# Fault Handling in the refactored APSU FSMs

(comments #109,140)

Luz Osorio, Nokia  
Tom Huber, Nokia  
Marco Mascitto, Nokia

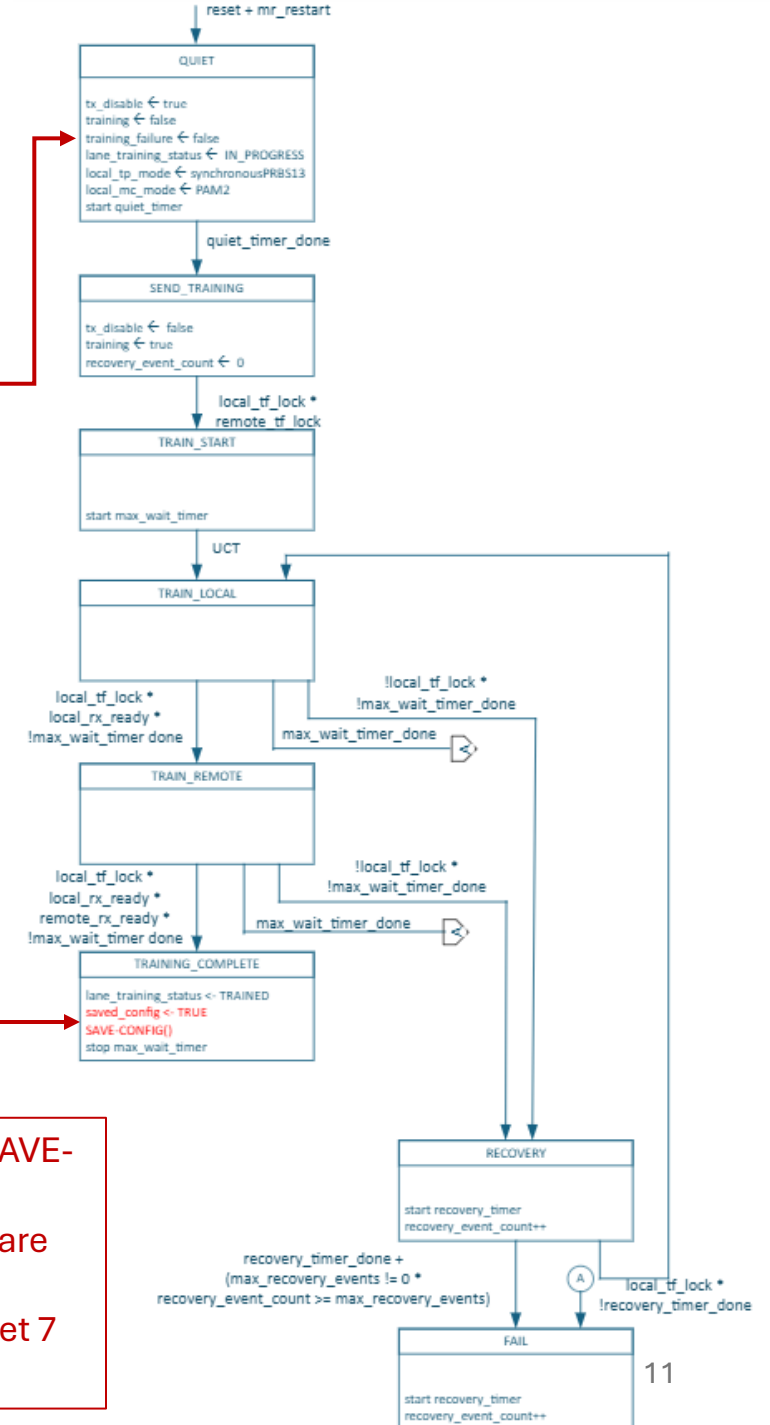
Proposed change to 178B-10 (ILT FSM): Add SAVE-CONFIG() function to TRAINING\_COMPLETE. Once training is complete, coefficient values are saved as preset 7. Set saved\_config = TRUE to indicate that Preset 7 has been updated from “initialize”.

## A. Adjacent ISL failure with replacement signal

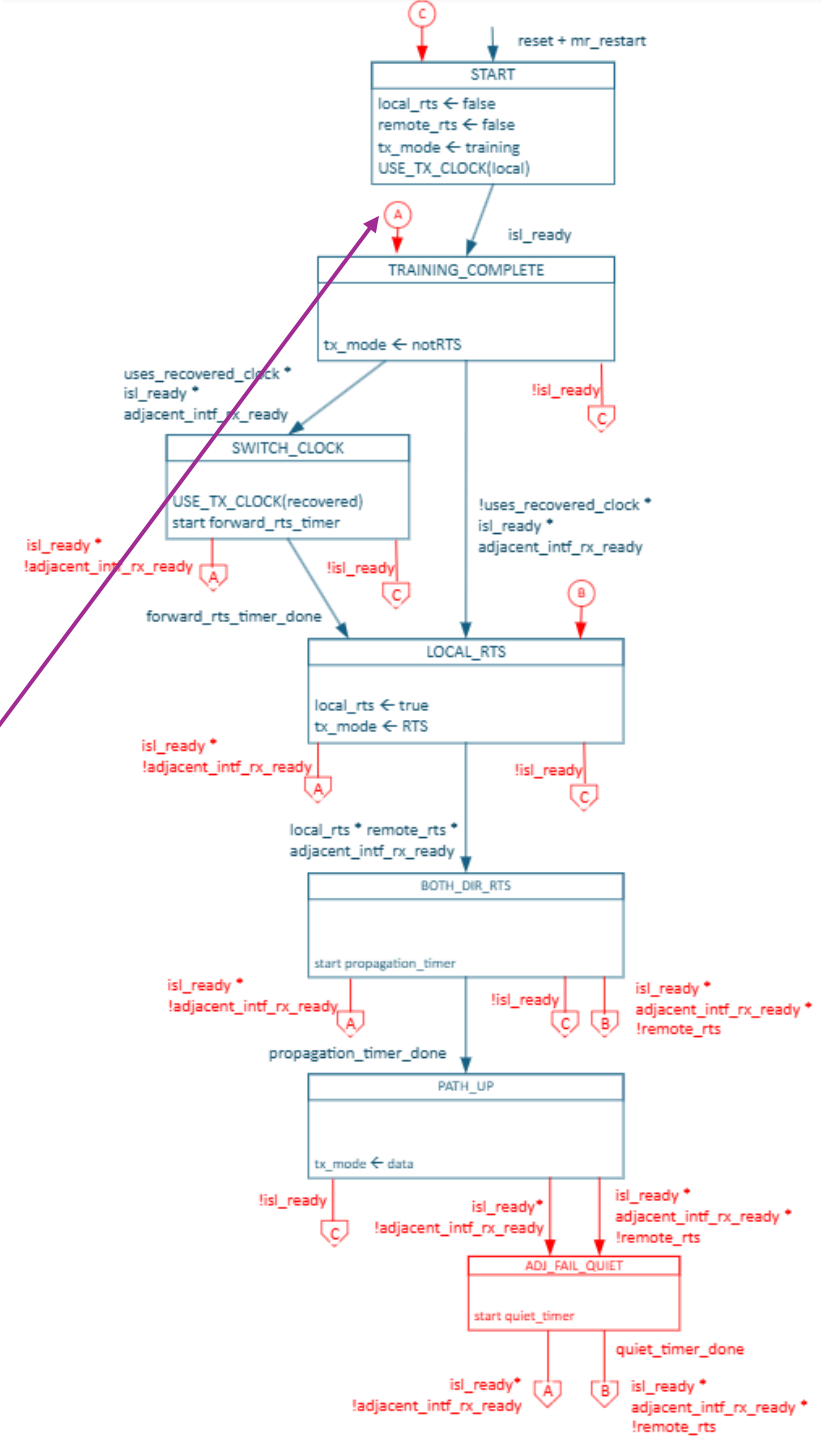
- Local signal does not need to be retrained because it was not disrupted (isl\_ready)
- Local signal is !RTS because !adjacent\_intf\_rx\_ready.
- Local interface detects replacement signal (1), after a quiet period the transmitter (2) switches to tx\_mode = notRTS.
- Wait until adjacent\_intf\_rx\_ready to switch clock and go back to RTS.

## B. Adjacent's Adjacent ISL failure with replacement signal

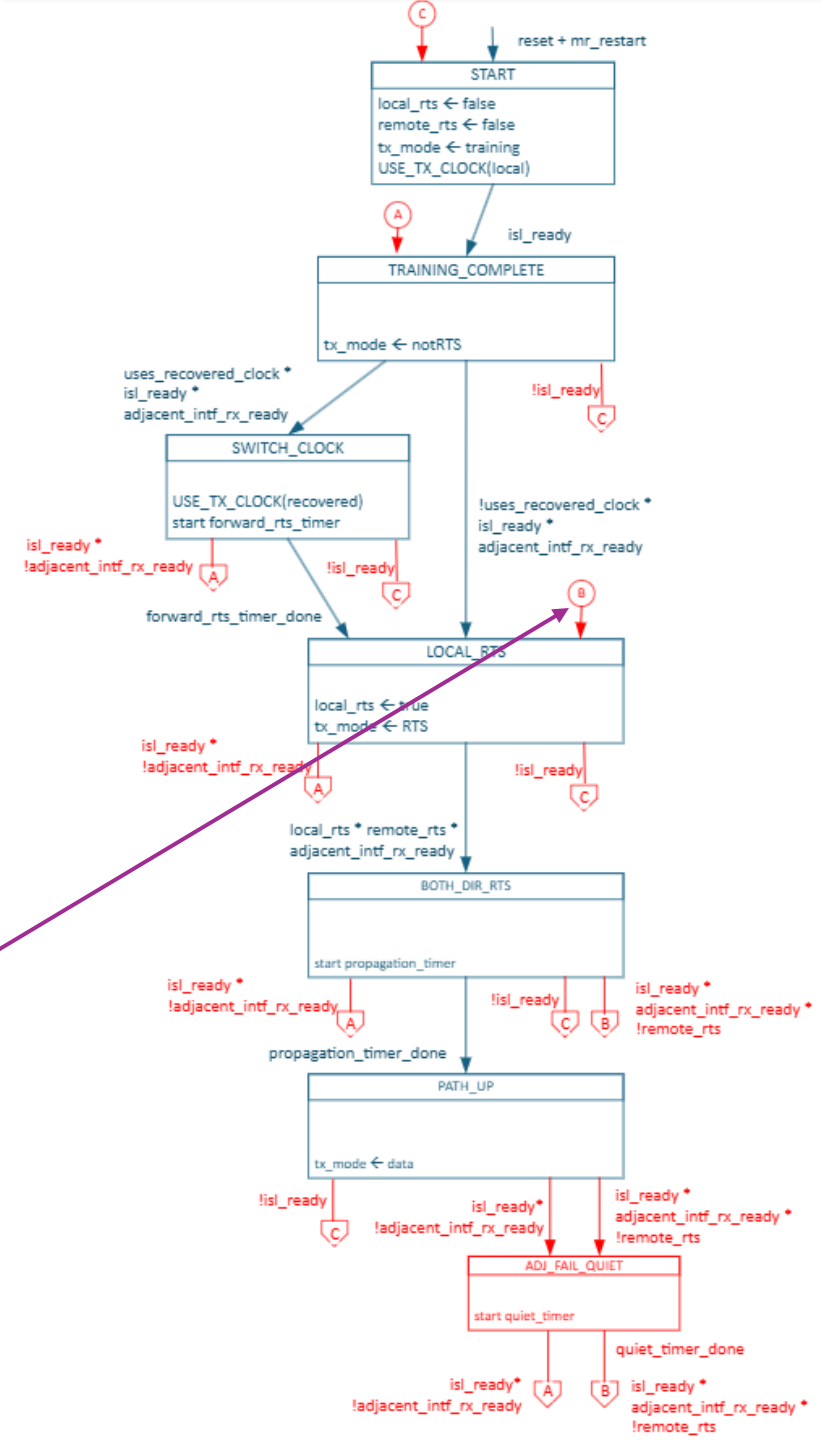
- Local signal does not need to be retrained because it was not disrupted (isl\_ready)
- Adjacent signal is ready because it was not disrupted (adjacent\_intf\_rx\_ready)
- Local interface detects replacement signal (1), after a quiet period the transmitter (2) switches to tx\_mode = RTS.
- Local signal is RTS but receives !remote\_rts. Wait until remote\_rts.

## C. Local ISL signal failure

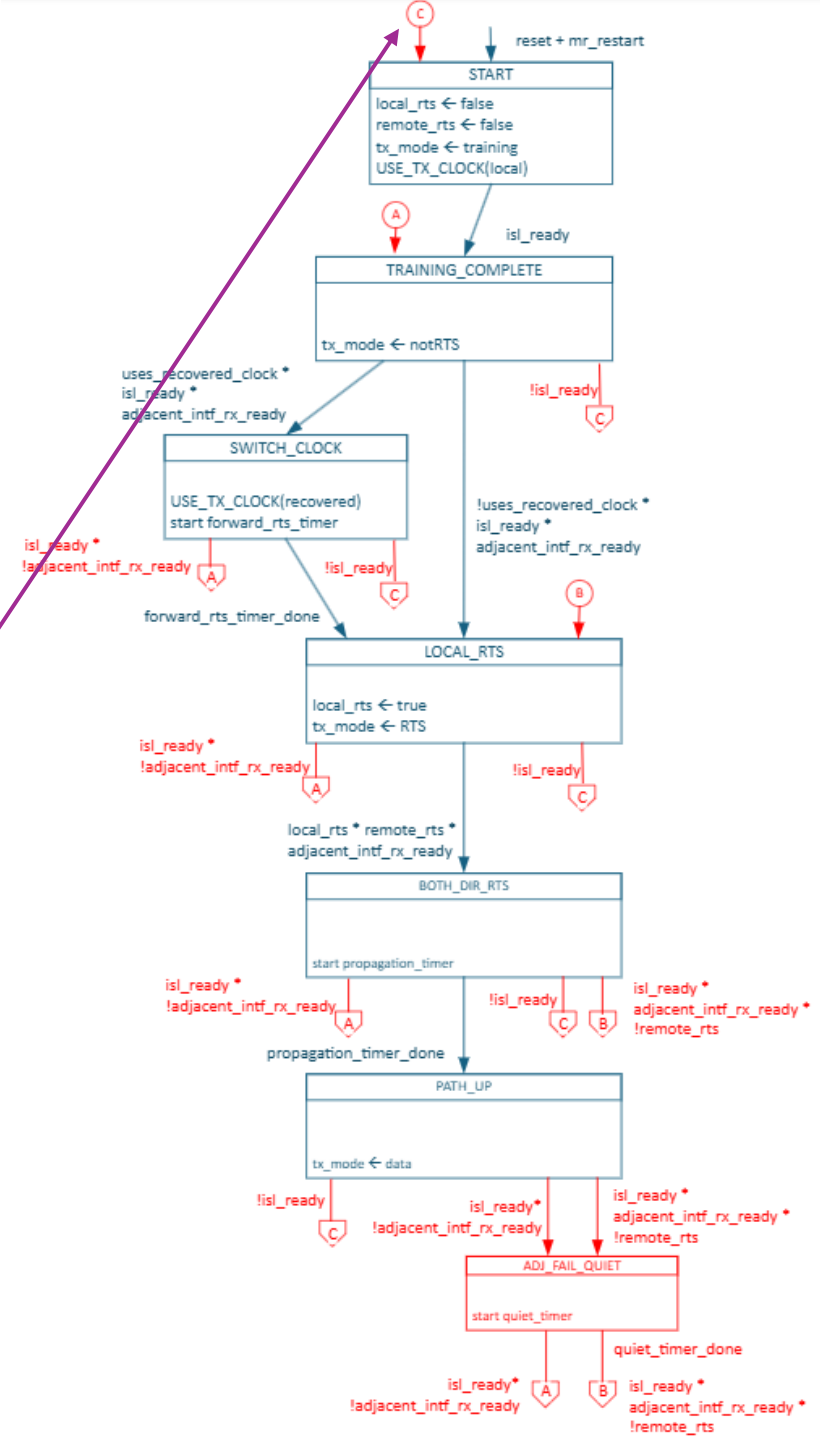
- Local signal is disrupted to !isl\_ready
- Upon recovery, local signal must be trained to guarantee optimal performance -> tx\_mode = Training
